In Reply Refer To:
HTA-TX

Road Safety Audit

Martin Luther King Jr. Blvd

Dallas, TX

Figure 6: Crosswalk near the DART station. The addition of pavement markings and a right-side warning sign would increase conspicuity for drivers, particularly at night.

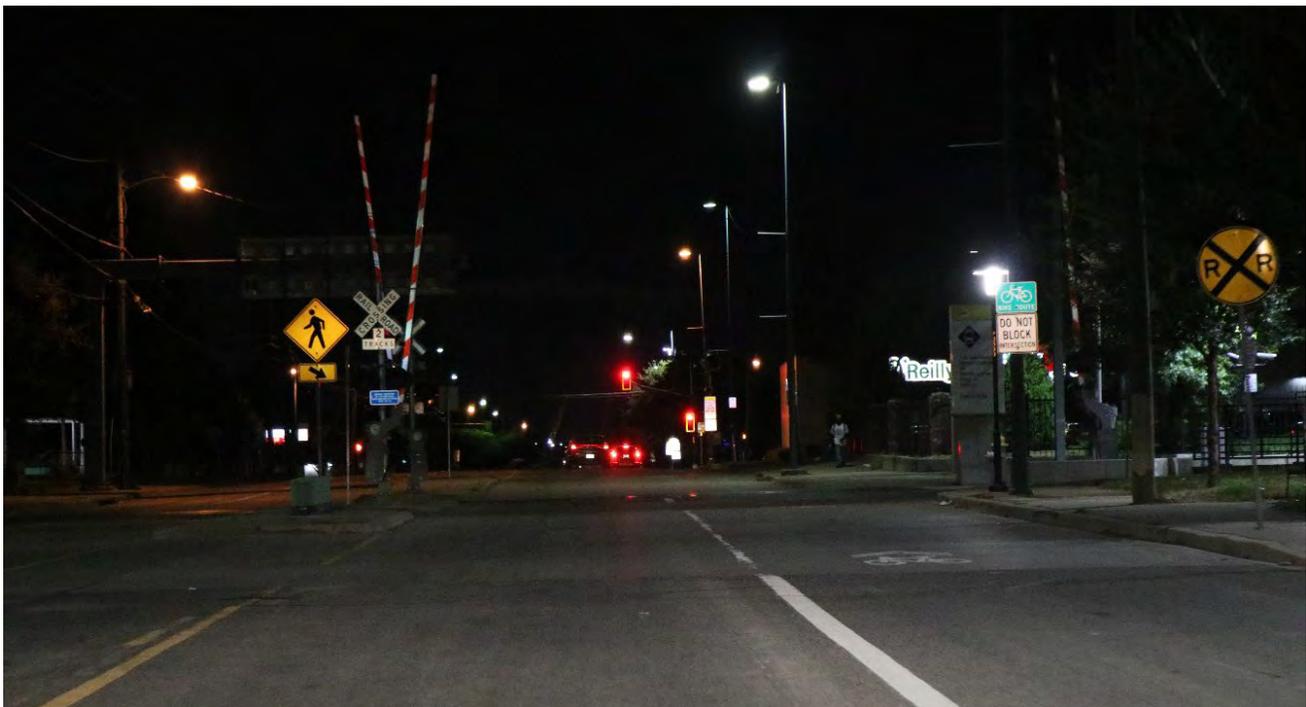
The DART Green Line station for MLK generates a large volume of pedestrian and bus movements in the area. To the east, MLK has mostly wide sidewalks, pedestrian scale light fixtures, and small trees. The RSA team observed many people walking from the DART station to the Fiesta grocery store across the street. There is a small raised median in this area and brick crosswalks. Most people walking were observed to be crossing roughly diagonally using none or only part of the existing crosswalk. Crosswalk warning signs were only present in the median, but not on the right side of the street for either approach.

Figure 12: A person on a bicycle crosses MLK during the morning rush hour.

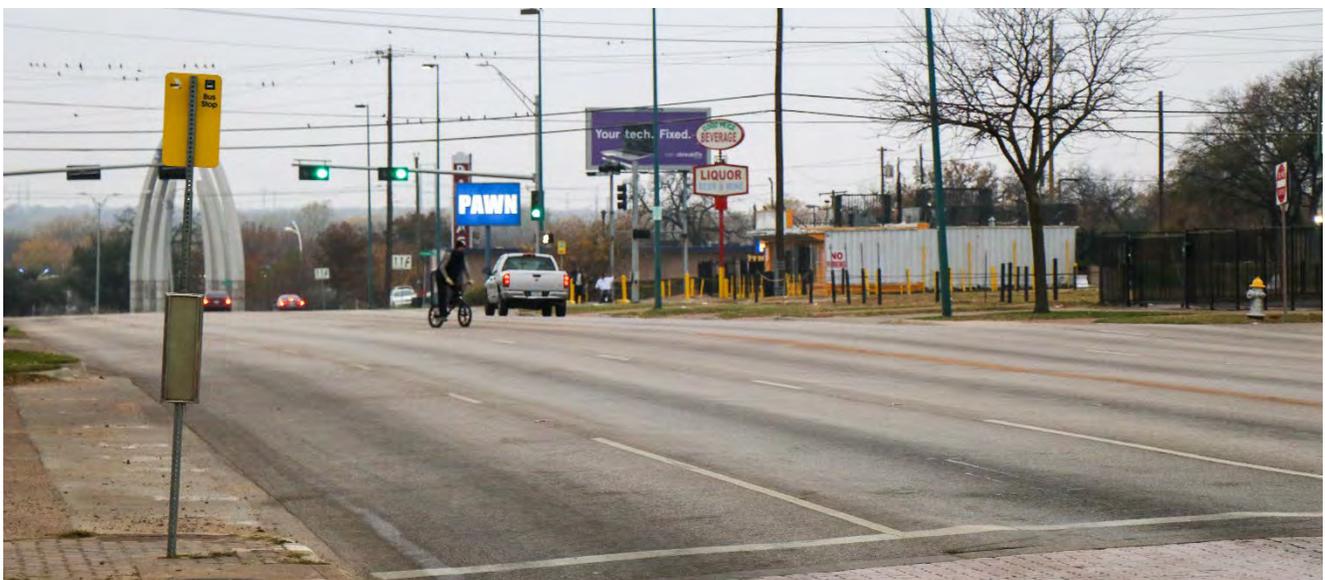
This portion of the MLK corridor is unique in that it is a six-lane undivided cross section. There are bus stops throughout this portion of the corridor, but limited benches and shelters. Many crossings on foot were observed in this area, both in defined crosswalks and between crosswalks. There is a raised median that stops at Cleveland street on the west, and the IH-45 work will add a raised median in advance and through the frontage road intersections. This portion of the corridor had the highest concentration of pedestrian and bicycle crashes, particularly near the Holmes St intersection (discussed in further detail later in this report). There are several liquor stores in this area and along with other social issues do contribute to the number of pedestrian crashes observed. The presence of six lanes without turn lanes means that drivers have more opportunity to speed through the part of the corridor, which may also contribute to the severity of crashes reported in this segment. Businesses have a mixture of parking access, with some pull-in angle parking and some long driveway cuts that are being used as perpendicular parking, results in vehicles backing into the travel lanes when leaving.

-
- **Observation:** The observed traffic in the area doesn't seem to justify the additional through lane that is present on the section. It allows greater speeds than a smaller section, which may be increasing injury severities when crashes do occur. **Recommendation:** A 6-to-4 or 6-to-5 lane road diet in the section would accomplish several goals, particularly if implemented along with a raised median. By making the roadway feel smaller, drivers would likely drive slower. This may help reduce injury severities, particularly with the observed pedestrian crashes. A median would limit the number of access points and turning conflict movements, and allow people walking to cross MLK in two stages, having to judge fewer lanes of traffic at a time and providing a safe refuge in the median. A left turn lane could be added at Colonial, improving safety and operations of that intersection.

Figure 6: Schematic of the I-45 and SM Wright construction plans provided to the RSA Team by TxDOT. (Source: TxDOT)

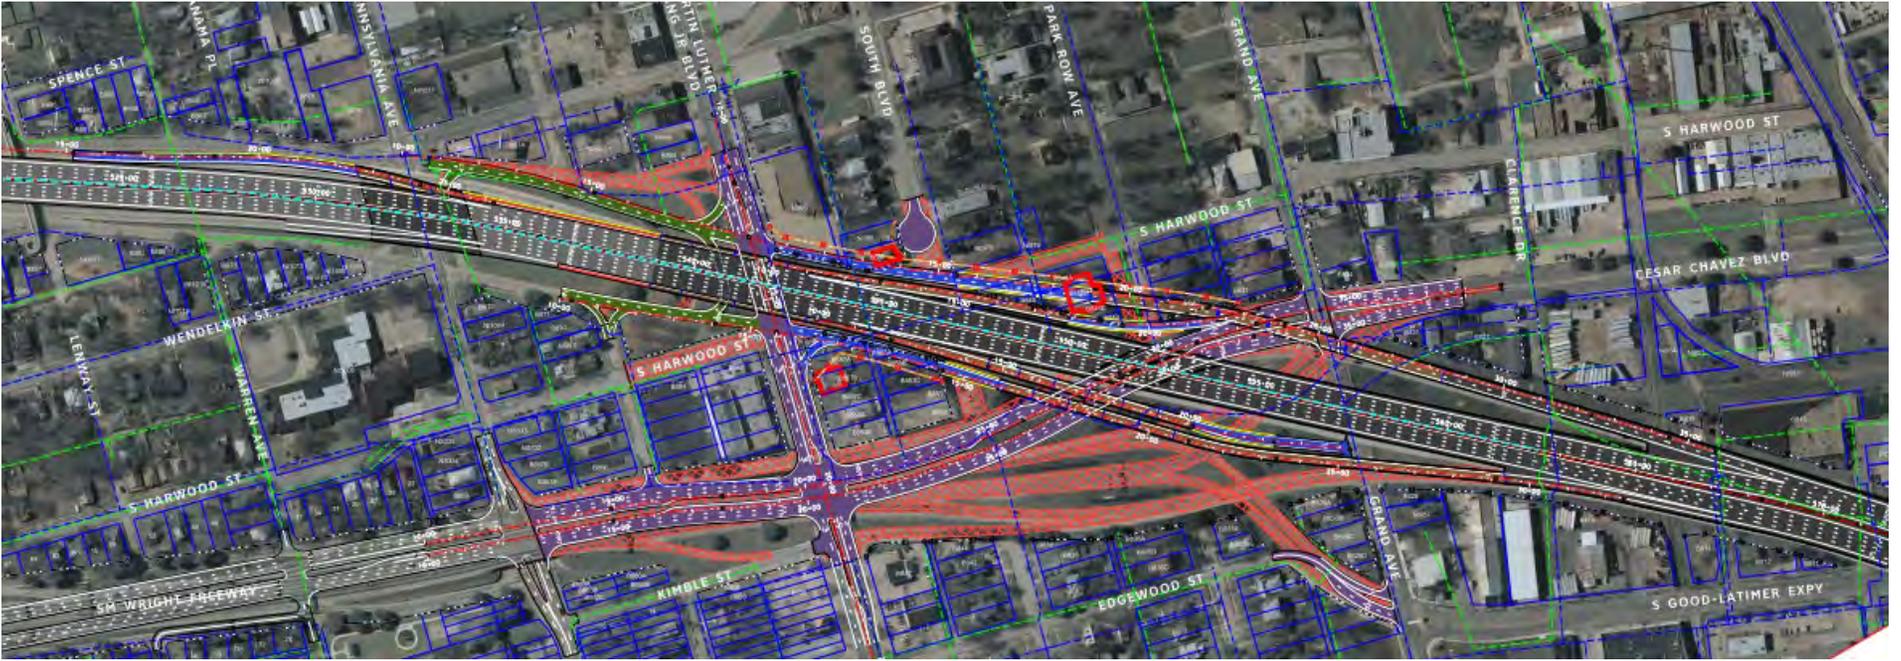
- **Observation:** At the proposed IH-45 frontage road intersections with MLK there right turn islands proposed in a relatively free-flow curved design that allows for higher speeds and has undesirable viewing angles. **Recommendation:** The City should work with TxDOT to change the design to match TxDOT's new right turn slip lane design, which features less curvature, which results in lower speeds,

- **Observation:** The proposed SM Wright and MLK intersection features a northbound approach with three through lanes in each direction, two left turn lanes, and a dedicated right turn lane. Walking along MLK will require crossing nine lanes of traffic and a small median area. This very long crossing will require very long crossing clearance times and will result in more people crossing without the walk sign. The size of the intersection also may mean that it is easier for drivers to do things like perform “donuts” which is a noted issue in the area. **Recommendation:** The City should explore with TxDOT if changes can be made to the design that would shorten the crossing and be more responsive to the high levels of pedestrian activity observed at this location. Removing a left turn lane, removing the right turn lane, or adding a right turn island, and narrowing the lanes may all be alternatives to the currently proposed design. The importance of peak hour traffic needs should be considered against the need to provide safe crossings 24 hours a day and the City’s goals for mobility along the MLK corridor.

- **Observation:** The proposed MLK cross section includes a wide outside lane of 14’ plus a 2’ offset to curb, along with 12’ inside lanes and turn lanes. **Recommendation:** If possible, the City should determine its preferred proposed bicycle accommodation treatment (shared use path, separated bicycle lane, bicycle lane, shared lanes) quickly enough for TxDOT to accommodate in the construction that will begin no later than September 2022. This would minimize the amount of changes needed to be made for the ultimate corridor effort in the long term. The City should also ensure that lane widths and curb offsets match City standards and that the proposed design does as much as possible to reflect City and stakeholder goals for the area.

- **Observation:** The width of proposed sidewalks along MLK could not be confirmed by the RSA team at the time of the review. One plan set said 6 feet wide directly behind the curb, while another person said the sidewalks would be 4 feet wide. **Recommendation:** The City should confirm the planned design, with

more yielding to people walking, and easier viewing of cross traffic than the proposed design. A partially raised crosswalk to serve those walking along MLK should also be considered, to further emphasize the need for yielding for pedestrians.

a minimum width of 6 feet preferred, and a buffer space between curb and sidewalk preferred if space is available.

Figure 2: Conflicting and faded markings on the MLK westbound approach to TX 352

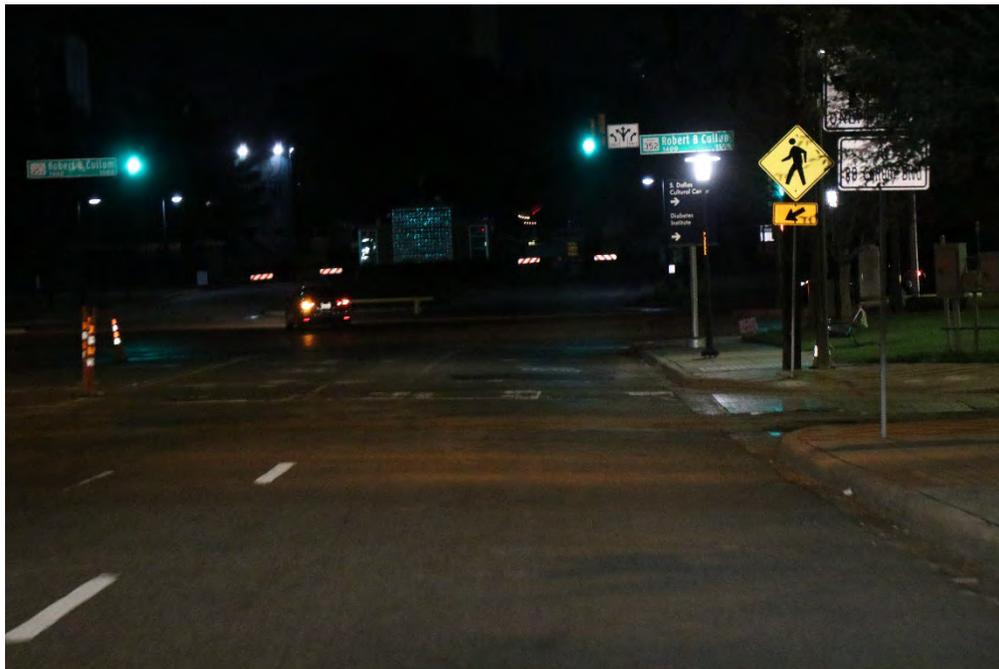
- **Observation:** On MLK just west of the intersection, the pavement condition was quite poor and through the asphalt what appeared to be an old brick crosswalk could be seen. This area was broken up enough that it was altering some drivers' behaviors, while it was also observed that many cars appeared to be bottoming out their suspension travel while traversing. It also made the pavement markings harder to see in the area. **Recommendation:** Reconstruct this approach and refresh the pavement markings.
